Technical Service Bulletin

19 Coolant pipe seepage on turbocharger

19 15 60 2036167/2 June 24, 2015. Supersedes Technical Service Bulletin Group 19 number 14-47 dated January 31, 2014 for reasons listed below.

Figure 1. Black, encrusted coolant residue (outlined area), coolant feed pipe (A), oil feed pipe (B), and coolant return pipe (C).

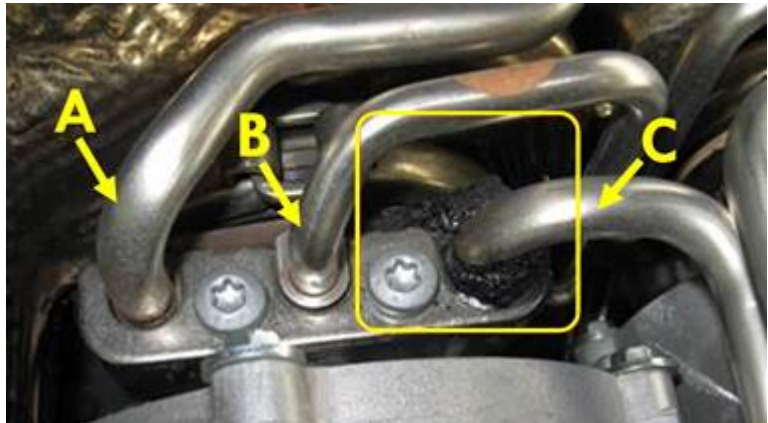
There may be slow coolant loss from the connections of the coolant feed pipe and coolant return pipe. High temperatures cause the coolant to become encrusted on the connection flange of the turbocharger (Figure 1).

Modified coolant feed pipes, coolant return pipes, and o-rings.

1. Drain the cooling system.
2. Replace the coolant feed pipes and coolant return pipes for both cylinder banks.
3. Replace the oil feed pipe o-rings.
4. Tighten the coolant line and oil line hold-down bolts to 9nm.
5. Fill and bleed the cooling system.
